BRAUM'S ADDITION

SITE PLAN TO SERVE
BRAUM'S ICE CREAM STORE
 ROCKWALL, TEXAS

I have had an opportunity to review the draft site plan for the Braum's location at Yellowjacket and SH-205 and there are some areas that need to be addressed. My comments are as follows:

Agenda Item: P&Z 91-20/SP/FP/CUP - Hold Public Hearing and Consider Recommending Approval of a Request from Braum's for a Conditional Use Permit for a Structure with Less than 90% Exterior Masonry Facade, a Site Plan and Final Plat on a Tract of land Located on Yellowjacket and SH-205

Site plan
1st submission

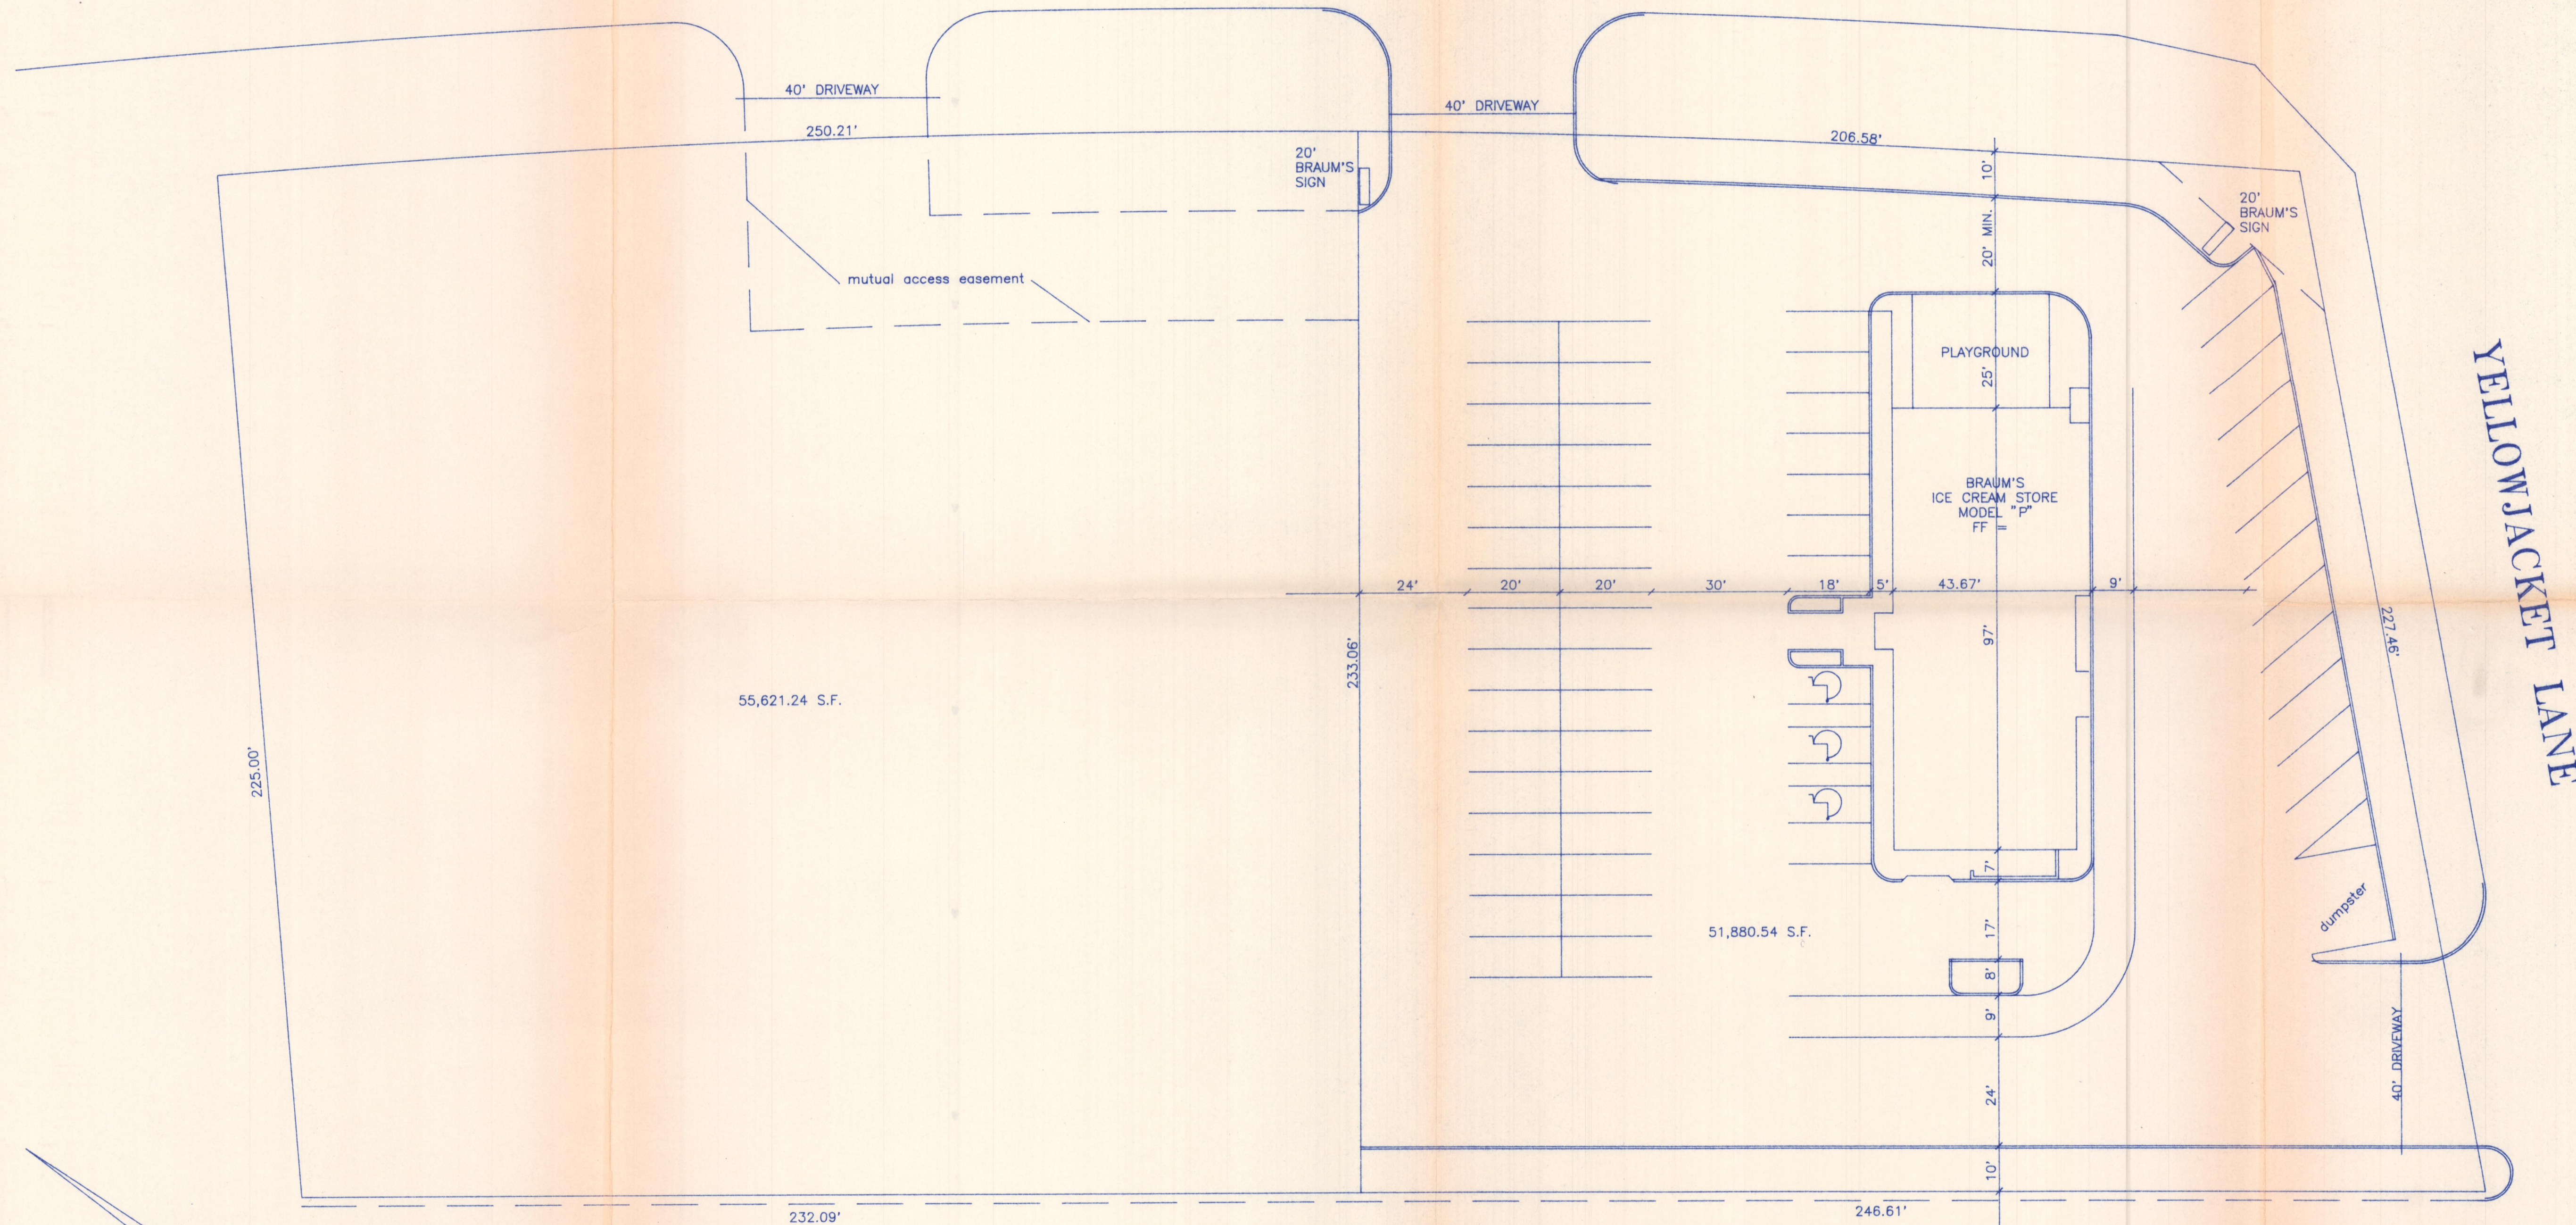
Landscaping - There is no landscaping information provided and you will need to provide that on your submitted site plan. You are required to provide landscaping internal to the parking lot totalling 5% of the parking lot area. On the enclosed marked up copy of the site plan I have shown an example of what could be done. If you need another copy of the landscaping ordinance let me know and I will get one to you.

✓ Signage - You are limited to one free standing sign not exceeding 20' in height or 60 sq. ft. in area. The sign must also be 10 feet from the street right of way line. Your plan shows two free standing signs.

Building Location - The building and the angle parking along the south property line are too close together for two way traffic. This drive would need to be signed as one way.

1. The two entrances onto SH-205 are located approximately 100 feet apart. Our current standards require that drives be located at least 200 feet apart unless a waiver is granted. The entrances are also unusually wide for the type of traffic that will be generated with your development. I would recommend that you consider a configuration of two 30' driveways approximately 150' apart and with the drive closest to Yellowjacket located approximately 150' from the intersection. Please indicate the radius dimensions on the drives. I would recommend that they be at least 20'. As we have previously discussed, when SH-205 is widened there is no median opening planned for this site.

2. I would also recommend that the entrance off of Yellowjacket be reduced from 40 feet. As shown the outside radius of this entrance will conflict with the radius of the adjacent driveway into the apartment. I would recommend that you curve the drive to form a 90 degree intersection with the road and move it off of the property line 27 feet at the

intersection. This will allow a full 15 foot radius for each drive. Again, there is no median opening planned for this area when the road is widened to a 4 lane divided section.

3. Also, please indicate the closest drives adjacent to this site on Yellowjacket and SH-205 as well as the location of any drives across the street.

Dumpster - The dumpster needs to be screened with a wall made of the same material as the main structure with a solid screen gate.

Sidewalks - You will have to include a sidewalk along the Yellowjacket frontage adjacent to the curb constructed in accordance with City standards.

3rd Submission
6-11-91

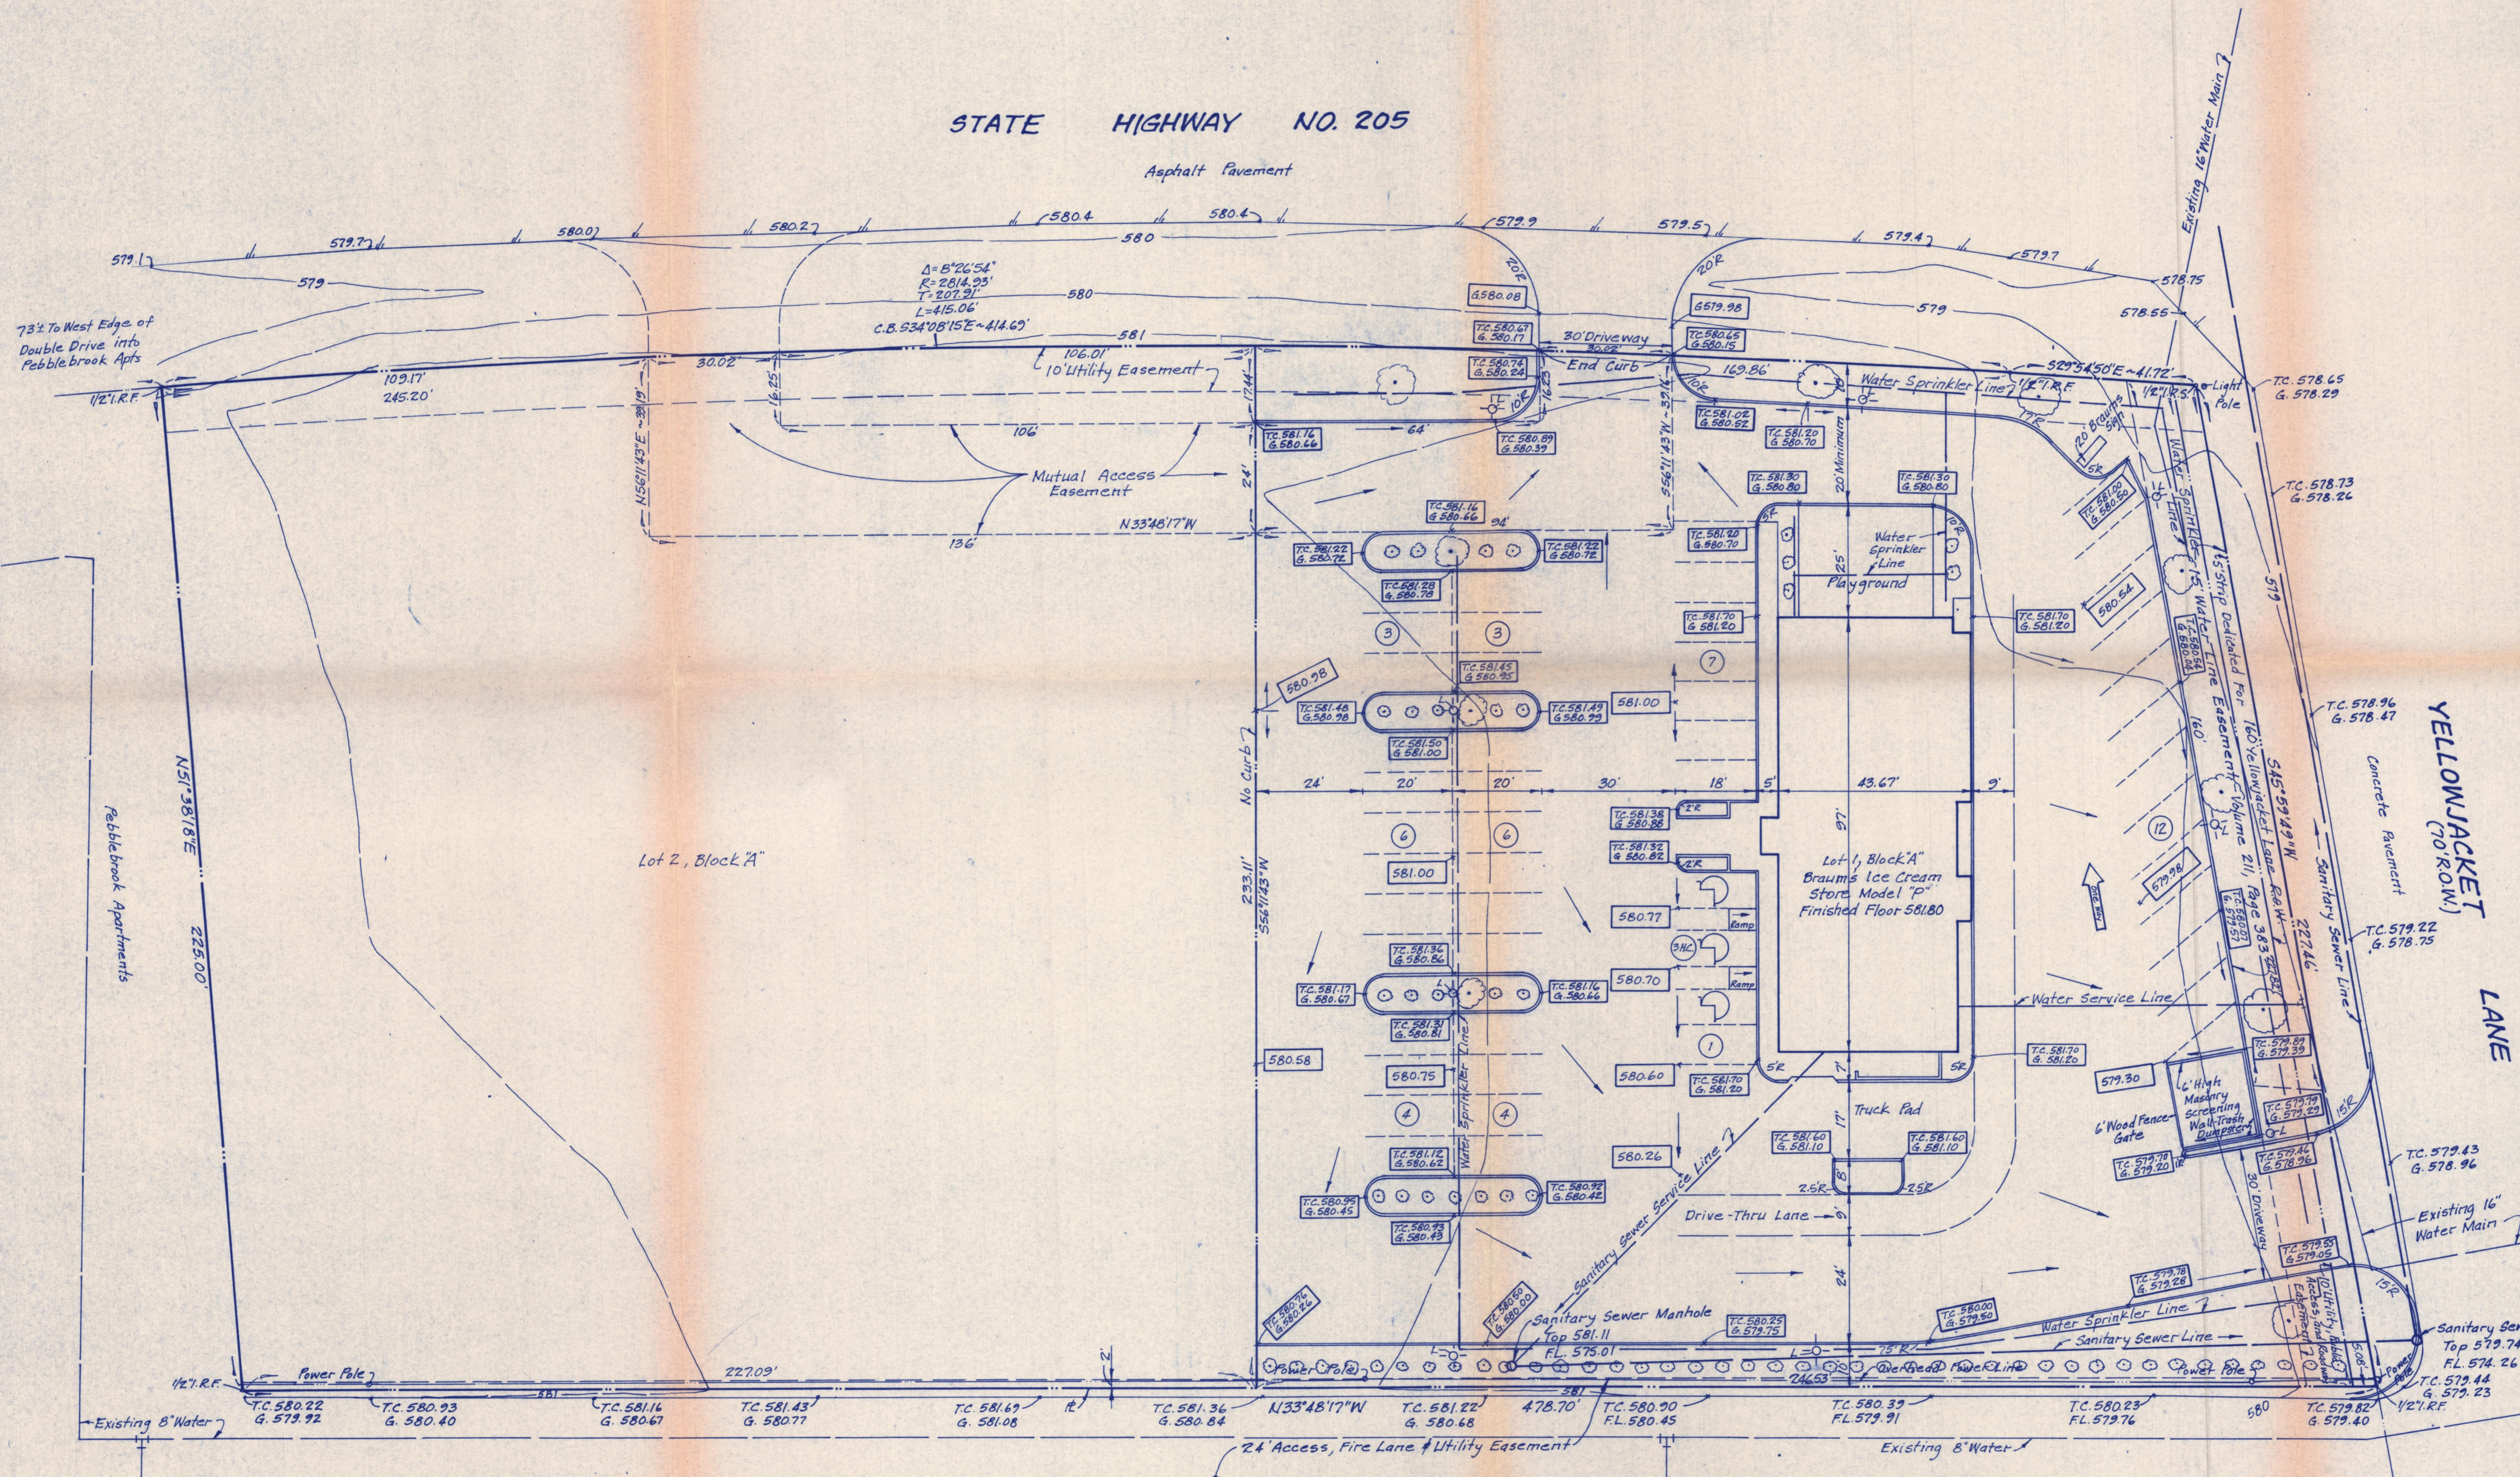
The following items are those changes that still need to be made to the site plan and plat for the proposed Braum's location:

1. An additional 275 sq. ft. of landscaping is needed in the parking lot.
2. A total of 3 trees need to be added to the parking area. The final location of the trees on Yellowjacket need to be decided prior to planting.
3. An additional 460 sq. ft. of landscaping is needed on the site.
4. The drives located on SH-205 need to be at least 170 feet apart.

The changes needed to the plat include:

1. The extension of the utility, roadway, and access easement along the full length of Yellowjacket.
2. The extension of the mutual access easement on SH-205.

1. Note grass in row + sprinklered
2. Need 275 add to in party area
3. need 3 trees in islands
4. Need 460 add to inside

298	- island
90	- trash
175	- playground
<hr/>	
563	
60	- entrance
<hr/>	
623	
5. Need to separate the drives on 5th - 205 170' apart
inside to inside
6. Check w/ Dots on tyage into 16" rather than 8"

1. Extend utility, access, roadway easent on Yellowgate
2. Extend mutual access easement

Agenda Item: Braum's Site Plan and Plat

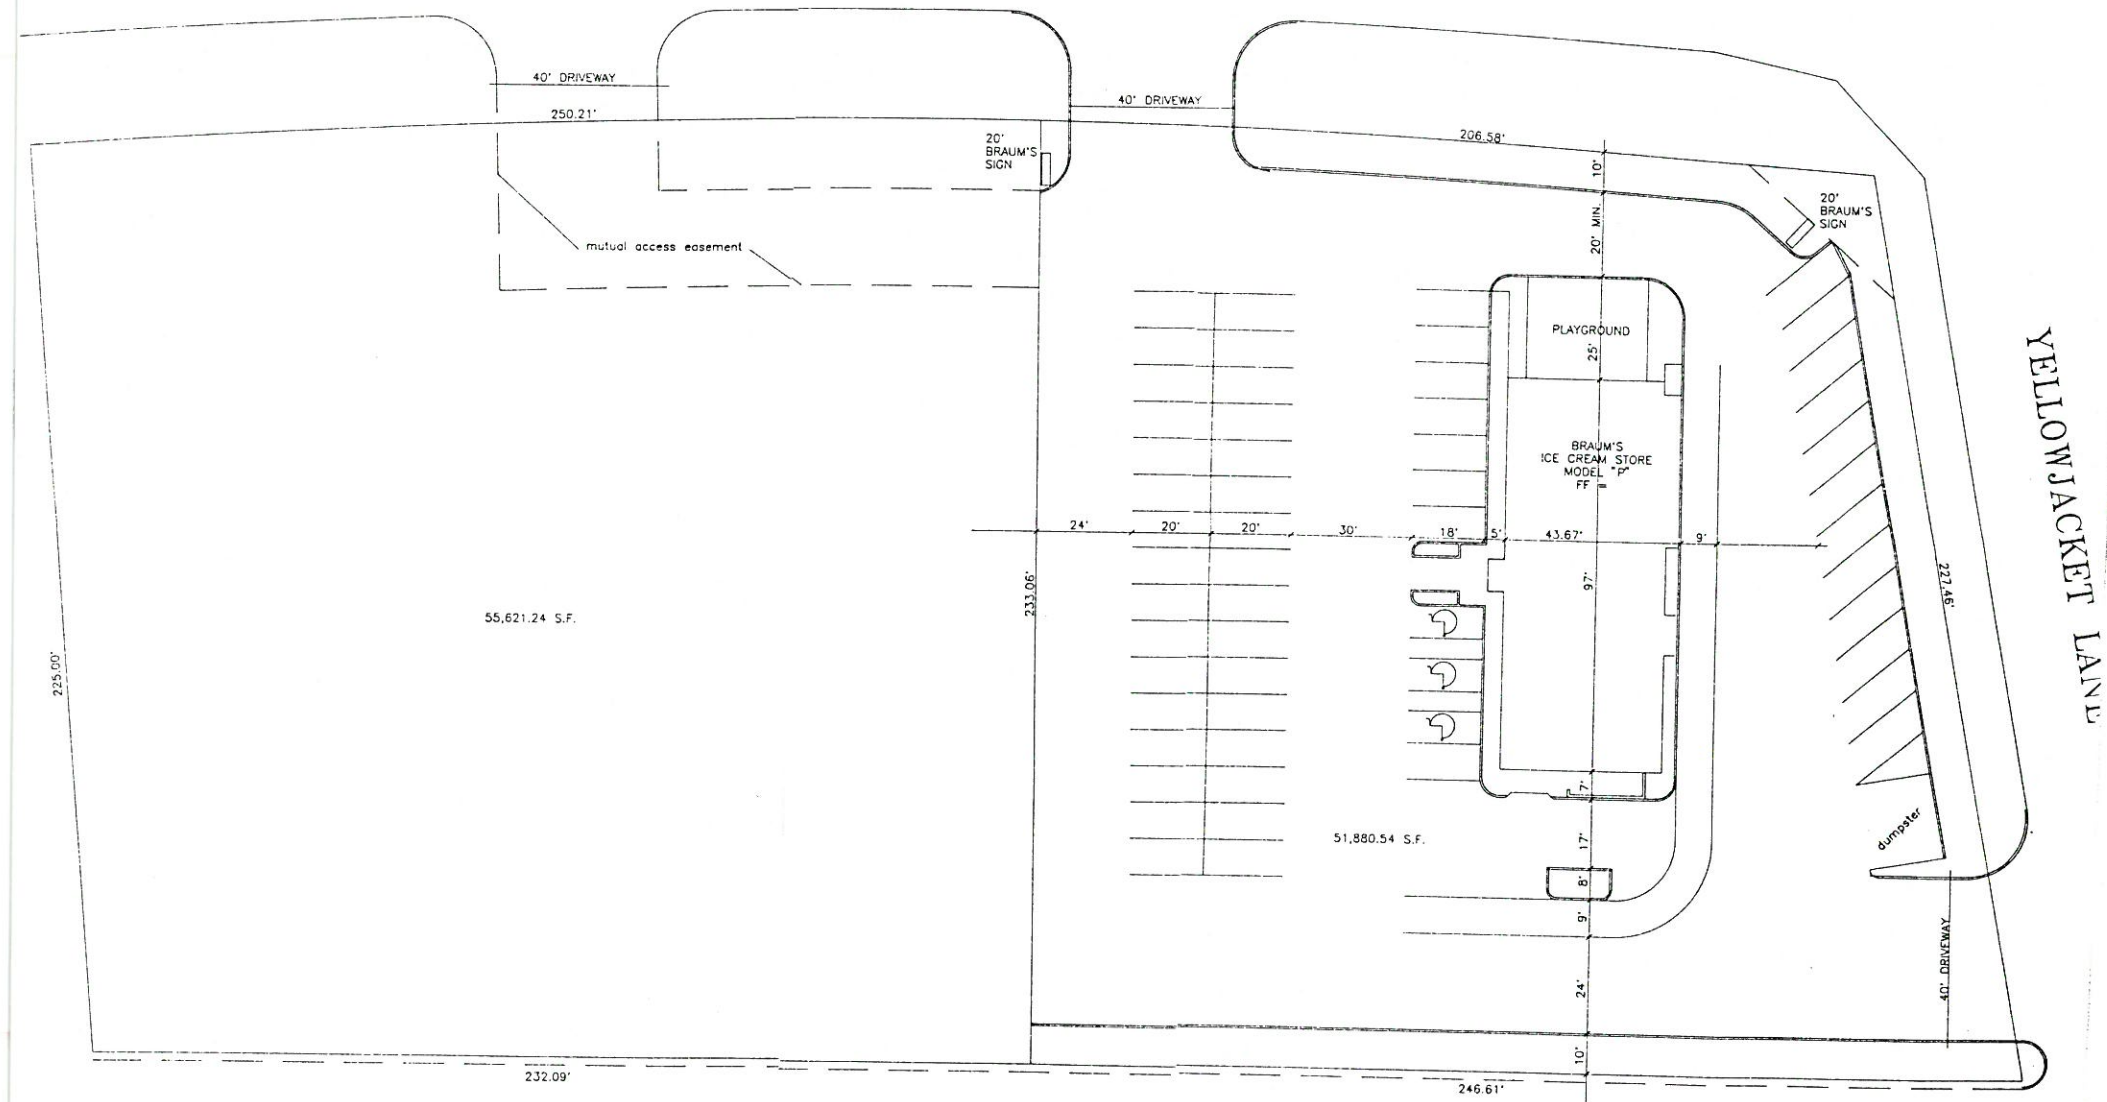
Signage - they are limited to one free standing sign not exceeding 20' in height and 60 sq. ft. in area. The plan shows two free standing signs.

Building Location - The building and the angle parking along the south property line are too close together for two way traffic. This drive would need to be signed as one way.

1. The two entrances onto SH-205 are located approximately 100 feet apart. Our current standards require that drives be located at least 200 feet apart unless a waiver is granted. The entrances are also unusually wide for the type of traffic that will be generated with the development. It was recommended to them that they consider a configuration of two 30' driveways approximately 150' apart and with the drive closest to Yellowjacket located approximately 150' from the intersection. The radius dimensions on the drives were also requested. It was also recommended that they be at least 20'. It was pointed out that when SH-205 is widened there is no median opening planned for this site.

2. It was recommended that the entrance off of Yellowjacket be reduced from 40 feet. As shown the outside radius of this entrance will conflict with the radius of the adjacent driveway into the apartments. Again, there is no median opening planned for this area when the road is widened to a 4 lane divided section.

Dumpster - The dumpster needs to be screened with a wall made of the same material as the main structure with a solid screen gate.

Sidewalks - A sidewalk along the Yellowjacket frontage adjacent to the curb will be required.
